HDV GTR achievements and discussion EVE IWG 74th session

Tokyo, September 18th
-hybrid-

Example: Re-definition of PTO and add ePTO

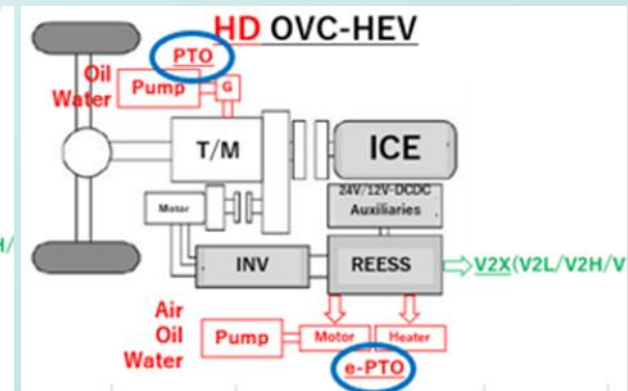
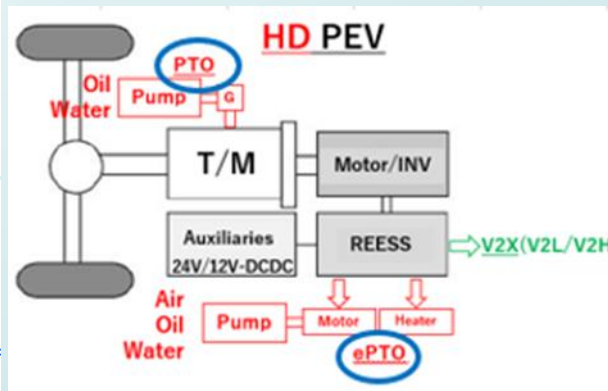
Definitions 2.51. of UN-R49-07 defines "PTO unit", but since PEV/OVC-HEV has the following PTOs, So new definitions of PTO and ePTO are required. (see below 3.17 and 3.**)

3.17. *Power take-off (PTO)* means supplying power from the engine (ICE, motor) to operate auxiliaries equipment unrelated to vehicle traction or normal vehicle auxiliaries(24V/12V-DCDC), such as oil pumps, water pumps (for concrete mixers, garbage trucks, fire trucks etc.)

3.**. *Electrical Power take-off (ePTO)* means a directly REESS that provides substantial auxiliary power for purposes unrelated to vehicle propulsion or normal vehicle accessories (Heater, 24V/12V-DCDC) such as air pump, oil pump, water pump (for Cargo Thermal Control trucks, Refrigerator trucks, Cabin heater and air-conditioning etc...)

Table 1
Battery Energy based (SOCE) MPR for Category 2 vehicles not exceeding 16 tonnes

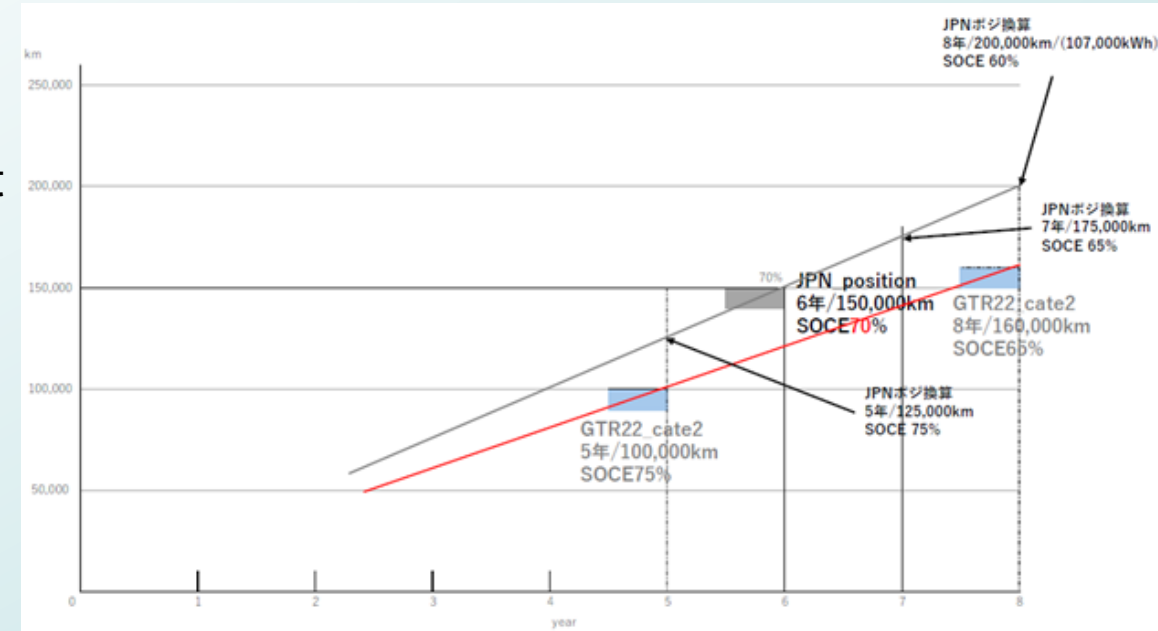
Dedicated comment on vehicles <16t

As with GTR22, we calculated the Energy Throughput which is the MPR index for 5 years and 8 years.

Battery energy based MPR for Category 2 vehicles not exceeding 16 tonnes	HD-OVC-HEV	HD-PEV
From start of life to years or km, whichever comes first and kWh in monitoring [and additional lifetime]		
5 yr or 125 000 km or Energy throughput [****] kWh	75%	75%
6 yr, 150 000 km	70%	70%
8 yr or 200 000 km or Energy throughput [****] kWh	65 60%	65 60%
8 yr, 300 000 km		
8 yr, 400 000 km		
10 yr, 300 000 km		
10 yr, 375 000 km		
15 yr, 250 000 km

Tolerance and pass/fail criteria for both part A and part B

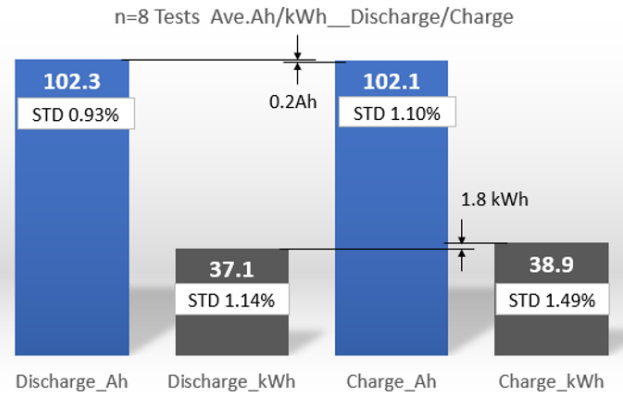
- Part A:
 - Test procedure for monitor verification 1a, 1b & 2 still being defined
 - Consequence: no extensive data yet for 1a, 1b or 2 test procedure repeatability
 - ➔ A factor & t_p , t_f parameters values to be confirmed **after monitoring phase**
- Part B:
 - MPR & 10% tolerance of pass/fail criteria for the family to be confirmed through monitoring phase
 - Monitoring phase of 2 years (2025-2027?) ➔ too short to secure field data covering fully Euro 7 mileage and years MPRs criteria
 - Practical proposal: cooperation with JRC on simulations & correlation with early ageing field data to confirm achievable MPRs

- Pass the family if $X_{tests} \leq A - (tP_{1,N} + tP_{2,N}) \cdot s$
- Fail the family if $X_{tests} > A + (tF_{1,N} - tF_2) \cdot s$
- Take another measurement if:
 $A - (tP_{1,N} + tP_{2,N}) \cdot s < X_{tests} \leq A + (tF_{1,N} - tF_2) \cdot s$

Results(2) Comparison UBE vs. UBC

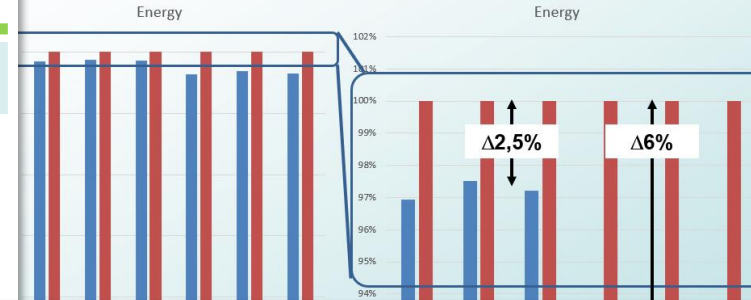
<Result>
 > UBE(kWh) ; Due to internal resistance, discharge is $\Delta 1.8$ kWh compared to charging. The variation is 1.14-1.49% which is much larger than UBC due to voltage multiplication.
 > UBC(Ah) ; Measured using DC charging and AC charging, The values are almost same, the difference is $\Delta 0.2$ Ah. Variation are 0.93 - 1.10 %.

- Capacity is the same in the charging and discharging phase (e.g. Coulomb efficiency approximately 100%)
- Capacity is more reproducibly measurable, since only the current sensor with very high accuracy (e.g. error $\ll 1\%$) is used.
- Capacity can be measured easily and reproducibly as well as technology neutral during the charging process at the charging station. Easy to replicate by third-party organizations or even by customers. Which leads to given transparency and possible validation at all time.
